City of Cranston

# City Plan Commission

September 1, 2020

# Replat Oaklawn Plat Lots 86, 87, 88, & 89

# VARIANCE PLAN

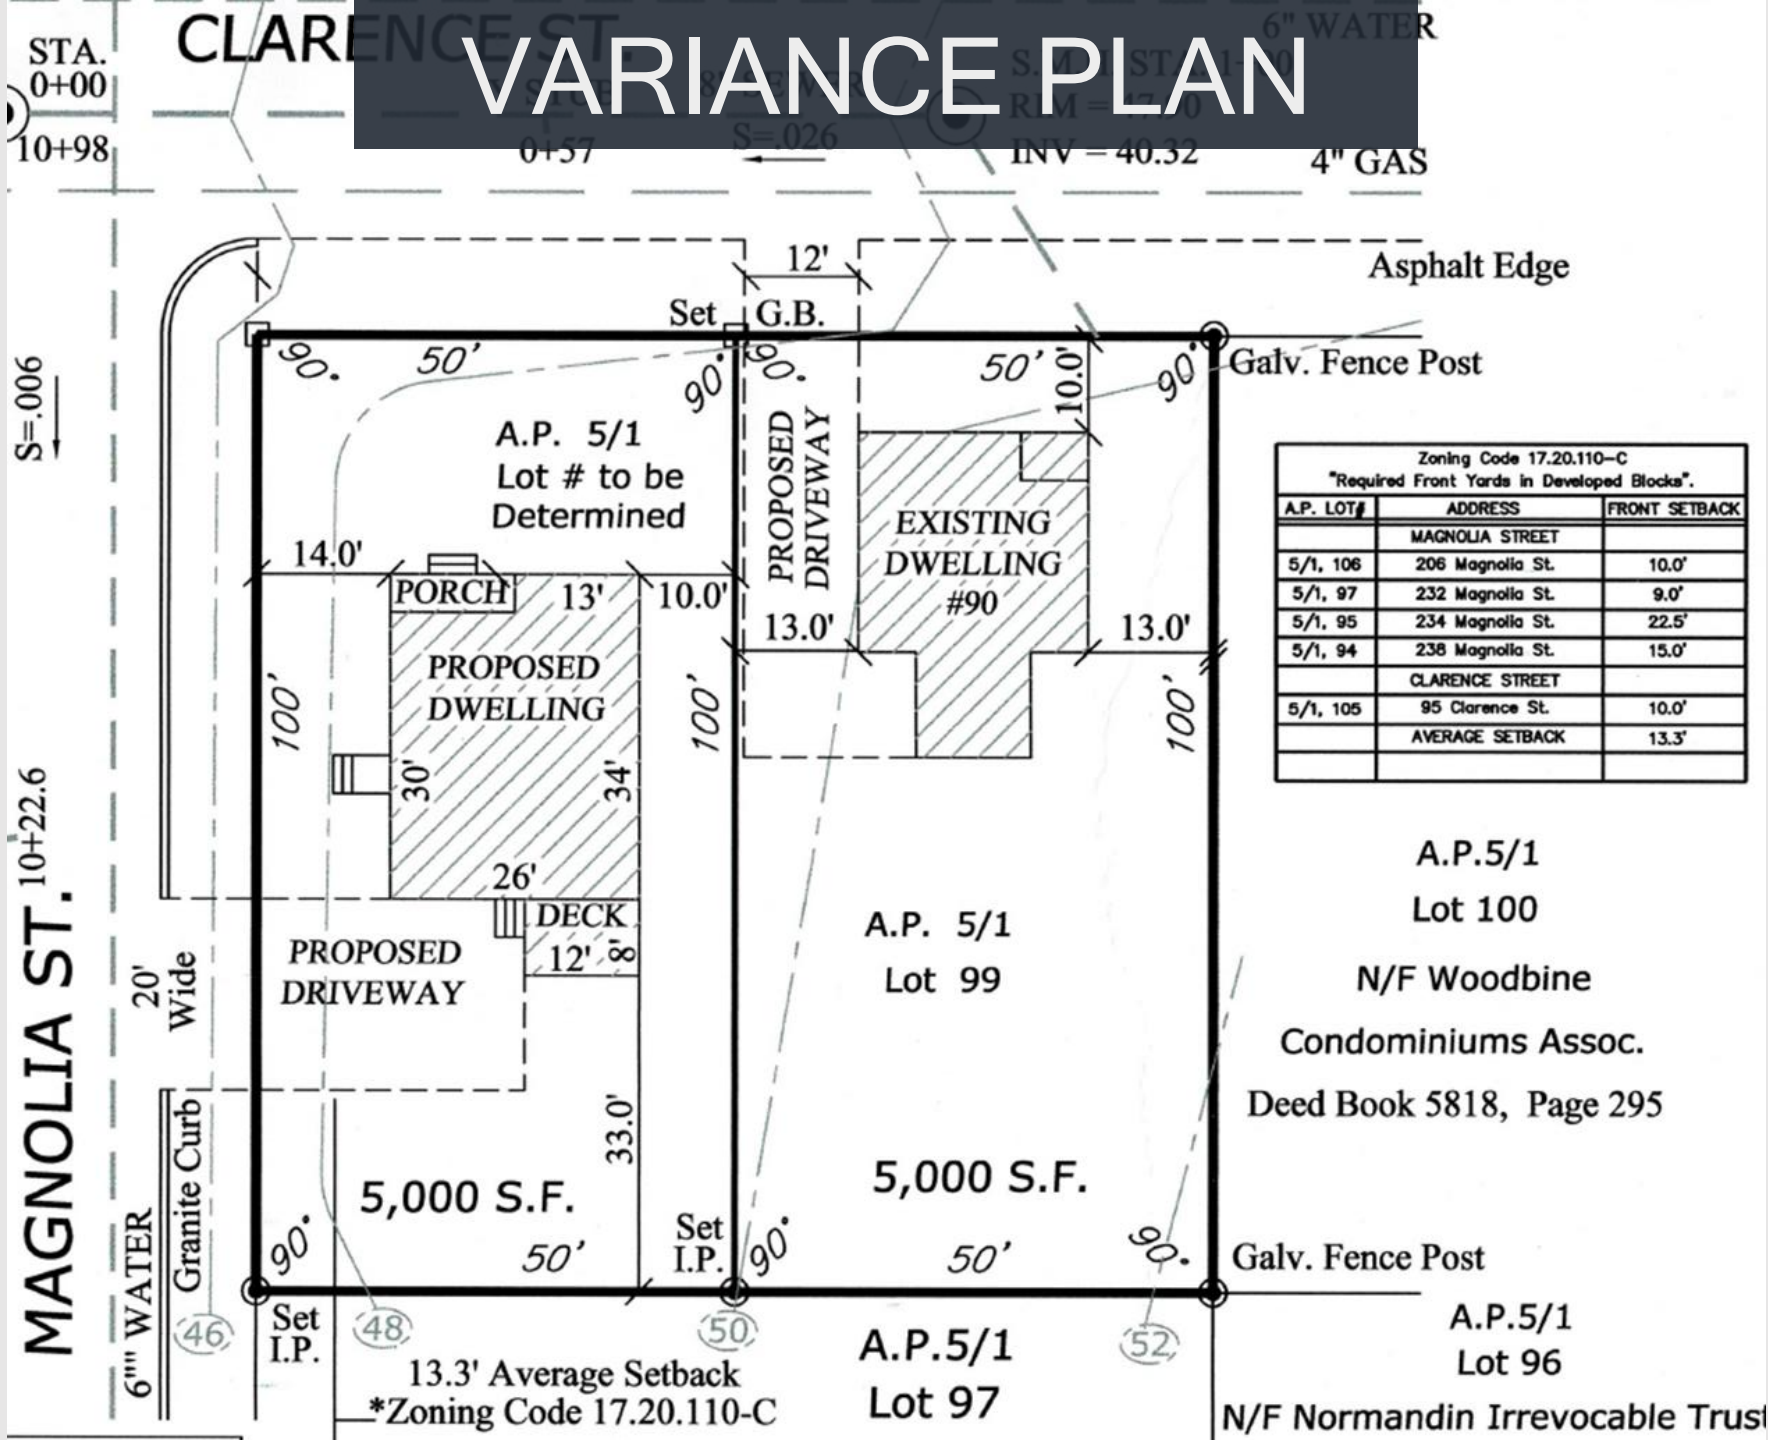
- If approved, the applicant intends to keep the existing single-family dwelling on 1 of the lots, and build a new single-family dwelling on the other lot.
- It should be noted this lot is a corner lot and subject to 2 front yard setback on each of abutting public rights-of-way. The proposed new dwelling is located 14' from Magnolia Street ROW, which is closer than standard front setback of 25', BUT is allowed by-right per the average alignment of abutting parcels per zoning code section 17.20.110(C).

Due to the fact that the application is consistent with the Cranston Comprehensive Plan, and due to the fact that the proposed lot size and frontage is consistent with the character of the surrounding neighborhood, staff recommends the Plan Commission forward a **positive recommendation** on this application to the Zoning Board of Review.

DRAWING NO:

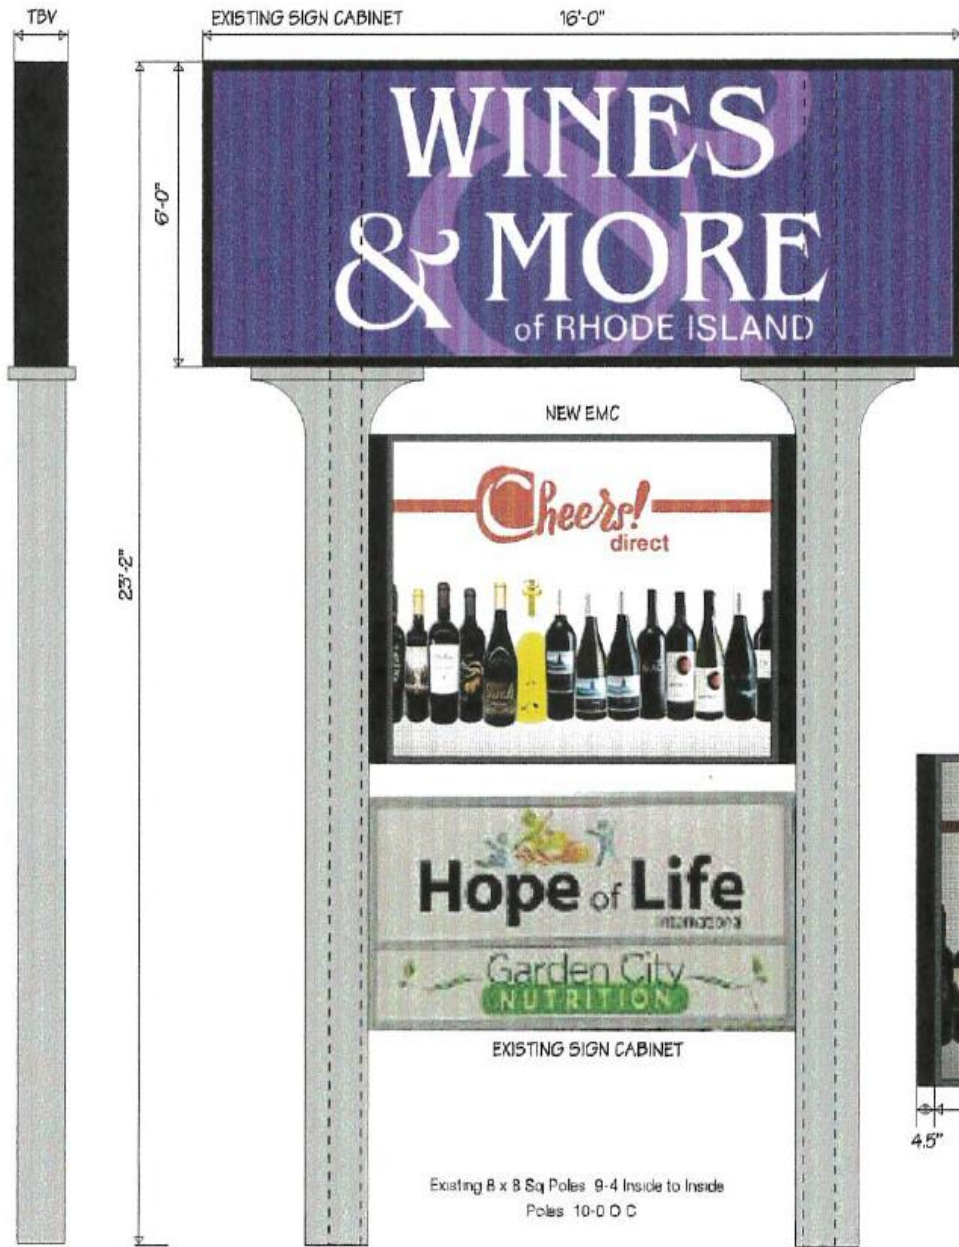
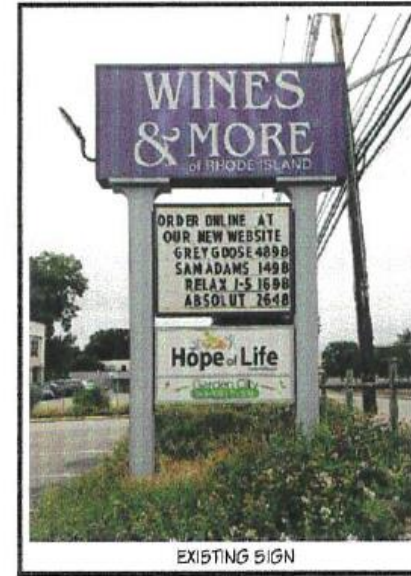
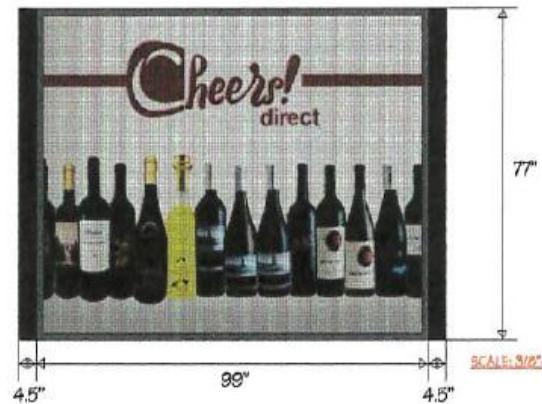
- The proposal does not increase the height or area of existing signage on the site, which the ZBR granted relief for in 2009.
- There are at least 3 other examples of animated signs on Sockanosset Crossroad alone, so relief would not be out of character with the area.

- Regarding animation and timing of images on the message board, the applicant clarified that *“the petitioner is requesting that a variance be granted to permit the digital sign to change every twenty (20) seconds to delineate products and items for sale at the establishment.”*

- Regarding brightness of the sign, the applicant has corresponded that *“the electronic message centers have automatic dimming capabilities and Watchfire Electronic message centers are equipped with a photocell that detects ambient light and adjusts brightness levels accordingly.”*

Due to the findings that the proposal is consistent with the Comprehensive Plan and the character of the commercial area, and due to the assertion that businesses should be allowed to replace changeable copy signs with animated signs (with restrictions), the Planning Department recommends that the Plan Commission forward a *positive recommendation* on this application to the Zoning Board of review, with restrictions to the sign's luminescence, animation, and frame change timing.
